REQUEST FOR COUNCIL ACTION

ITEM DESCRIPTION: Land Subdivision Permit (Preliminary Plat) #03-19 by Badger Hills LLC to be known as Badger Hills Subdivision. The Plat proposes to subdivide 79.50 acres of land into 171 lots for residential development and 5 outlots. The plat also proposes right-of-way dedication for public roadways. The applicant is also requesting approval of a Substantial Land Alteration to permit site grading that will modify grades by more than 10 feet on portions of the property. The property is located along the north side of Valley High Road NW, west of West Circle Drive and east of 50th Avenue NW.

BADGER HILLS SUBDIVISION
ROCHESTER, MINNESOTA
PRELIMINARY PLAT

RE: Land Subdivision Permit (Preliminary Plat) #03-19 by Badger Hills LLC to be known as Badger Hills Subdivision. The Plat proposes to subdivide 79.50 acres of land into 171 lots for residential development and 5 outlots. The plat also proposes right-of-way dedication for public roadways. The applicant is also requesting approval of a Substantial Land Alteration to permit site grading that will modify grades by more than 10 feet on portions of the property. The property is located along the north side

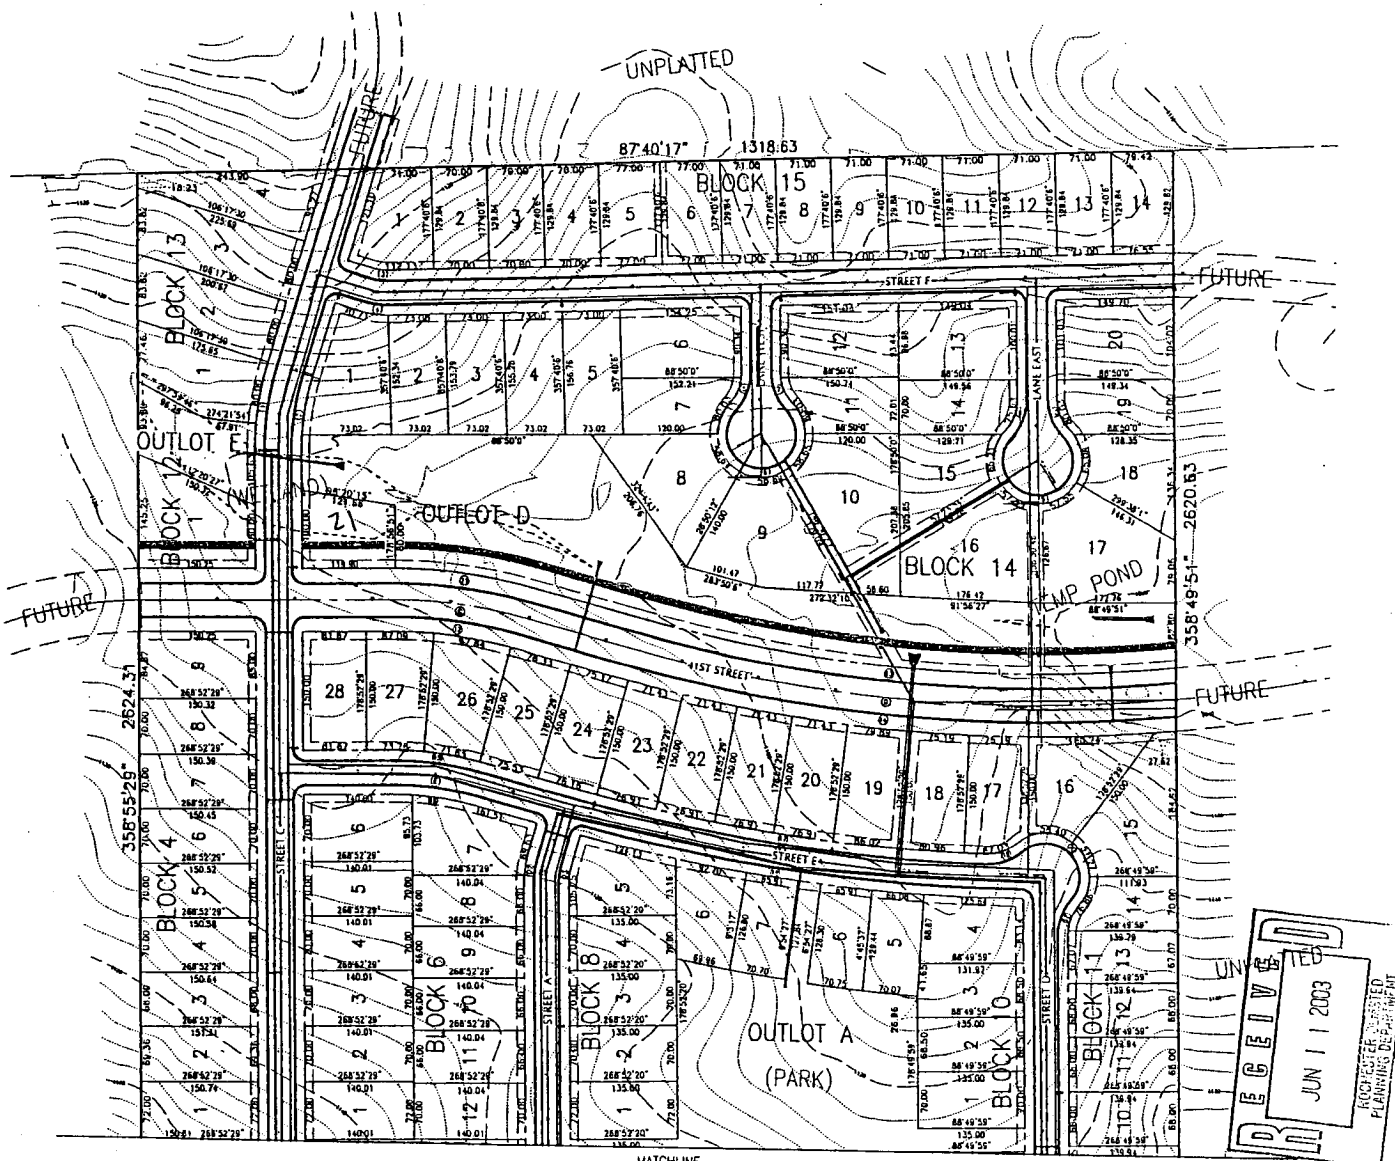
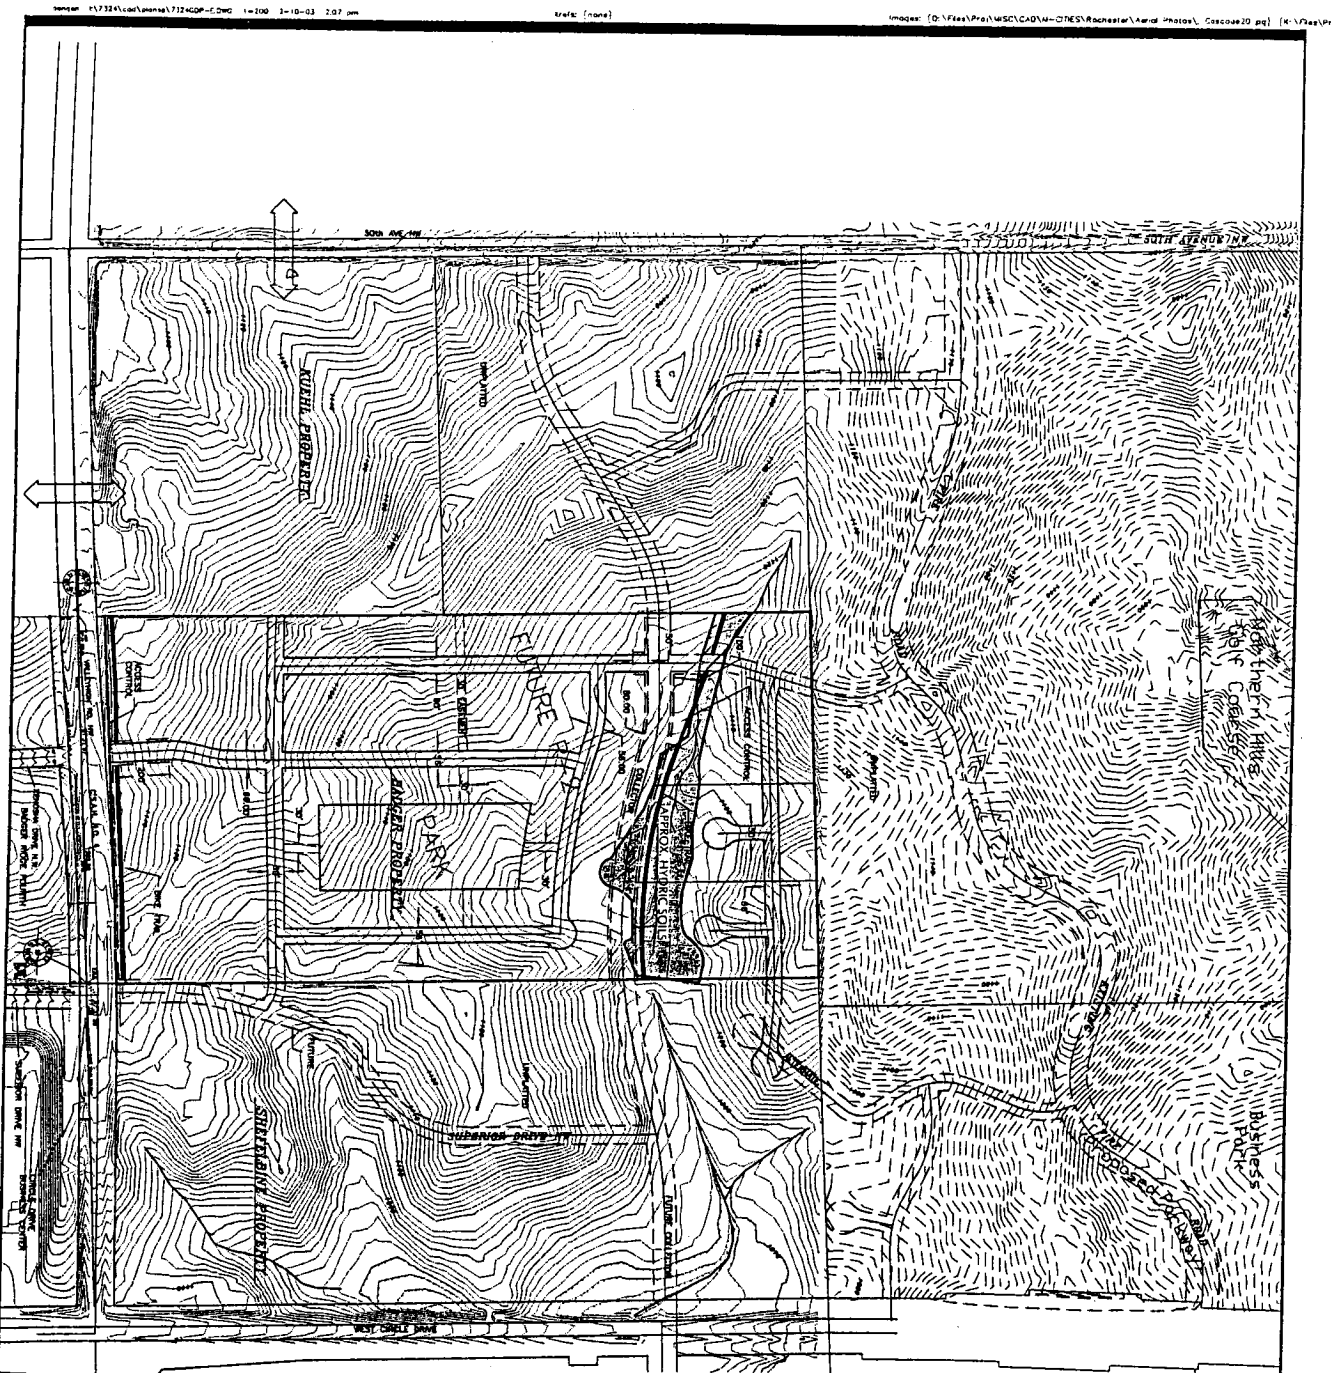
- a. ***Adding the directional of NW to 41 Street so it reads "41 Street NW".***
- b. ***Coordinating with the Planning Department – GIS Division, numbering or naming all other roadways within this plat.***

- c. ***The location map on the face of the plat shall be changed to Cascade Township coordinates T107N. Currently location map indicates Rochester Township coordinates T106N.***

- d. ***Providing an additional utility easement along the south lot lines of Lot 1, Block 1 and Lot 1, Block 2, as requested by Rochester Public Utility Water Division Memorandum, dated June 18, 2003 and Operations Division Memorandum, dated June 17, 2003.***

- e. ***Dedicating a 30' wide outlot mid-block connection in the vicinity of Lots 7 & 8 of Block 15, and two 30' wide outlot midblock connections in the vicinity of Lots 9 & 10 and Lots 19 and 20 of Block 11.***

- f. ***Indicating controlled access along the entire frontage of Valleyhigh Drive NW, with the exception of any approved street accesses. Additional controlled access is required within 250 feet of the right-of-way intersection of Valleyhigh Road NW and Avenue "A" and along the entire frontage of 41 Street NW.***

- g. ***Dedicating a public pedestrian facility easement, of sufficient width to accommodate construction and maintenance of said facilities, at no cost to the City for the pedestrian paths along 41st Street NW and Valleyhigh Road NW as shown on the preliminary plat outside of the right-of-way.***

41 Street is being called out without a directional. Add the directional of NW so it reads "41 Street NW". All roadways within this plat need have the numbering or naming coordinated with the Planning Department – GIS Division.

The pedestrian paths along 41st Street NW and Valley High Road NW are shown on the preliminary plat outside of the right-of-way. The Owner is obligated to dedicate a public pedestrian facility easement, of sufficient width to accommodate construction and maintenance of said facilities, at no cost to the City.

An additional 10' wide utility easement is required along the south lot lines of Lot 1, Block 1 and Lot 1, Block 2.
